Proudly Serving Rural Routt County \* City of Steamboat Springs \* Town of Hayden \* Town of Oak Creek \* Town of Yampa \* Routt County School Districts

Date: 03/24/2021

Subject Property Address: 2305 Mount Werner Circle

Permit Number: TB-21-204 Permit Applicant Name: ESA

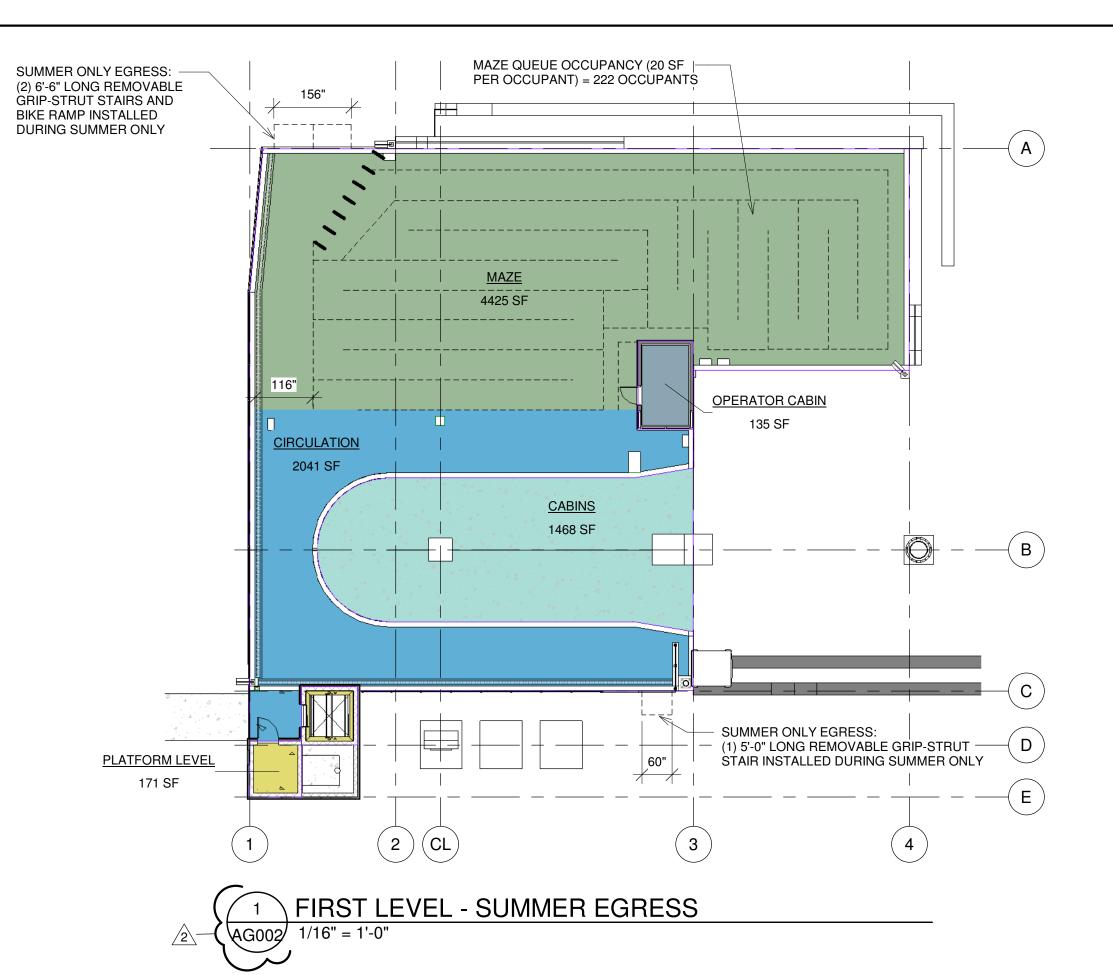
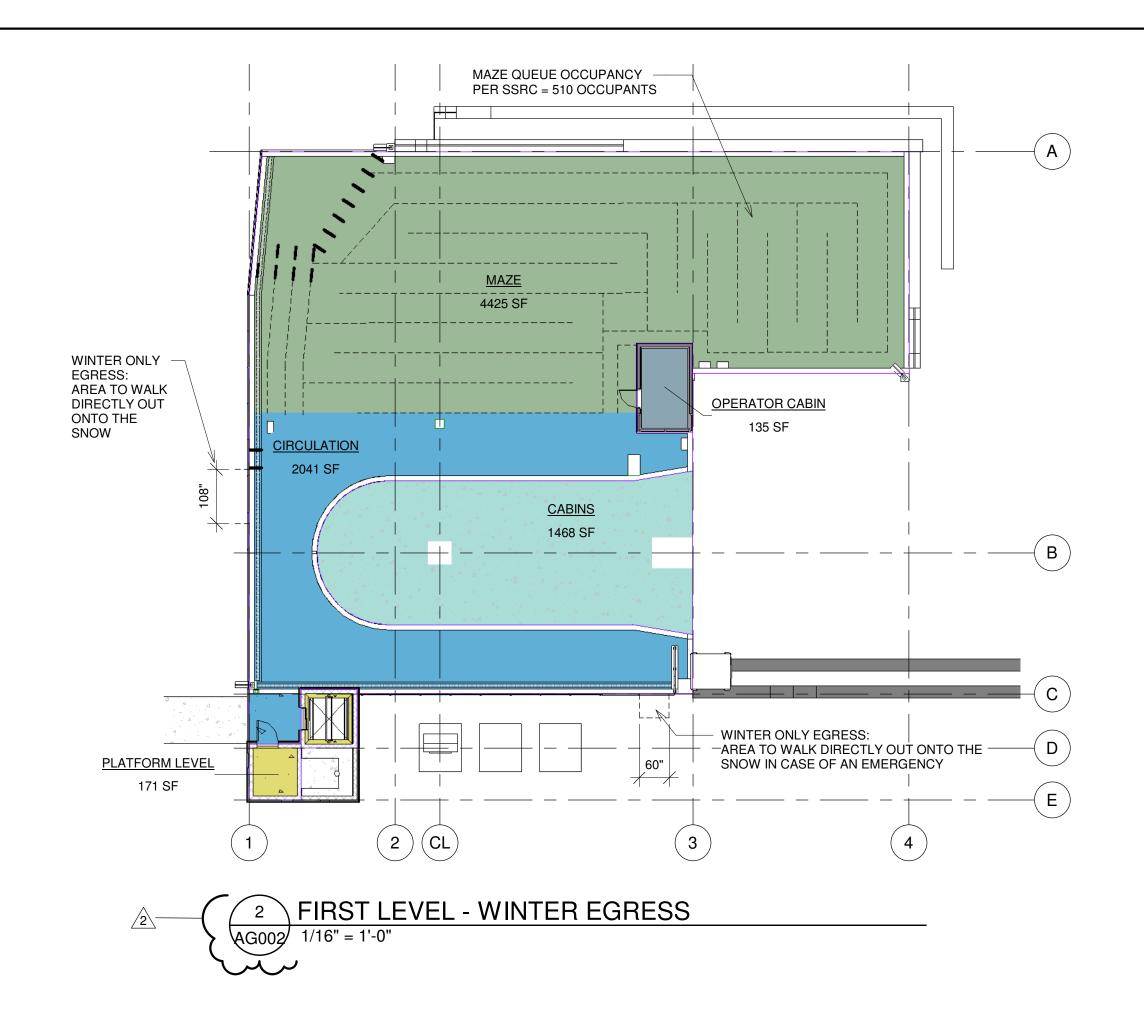
- 3. **Re-Submittal or Re-Calculation Requested:** On Sheet AG002 you provided an estimated Platform Occupant Load of 440 Occupants, this number was derived by using an Airport Terminal waiting area which utilizes 15 SQ FT per occupant as the dividing factor. RCRBD believes this is an inaccurate way to calculate true Occupant Load based on past experiences working with the Ski Corp in the existing Gondola Building maze area. In the past maze area occupant load has been calculated by using Standing Space out of table 1004.5 of the IBC which uses 5 SQ FT per Occupant. RCRBD believes this is a true and accurate number to be used for Ski operations related to occupants waiting in line. Please review this request, and if you object please provide us with a diagram of how the Ski Corp will utilize business practices to maintain spacing between occupants to adhere to 15 SQ FT per occupant under normal business operations not considering public health conditions that may create greater spacing. Please note this may affect your Code Analysis related Section 1005.3.25 on sheet AG002.
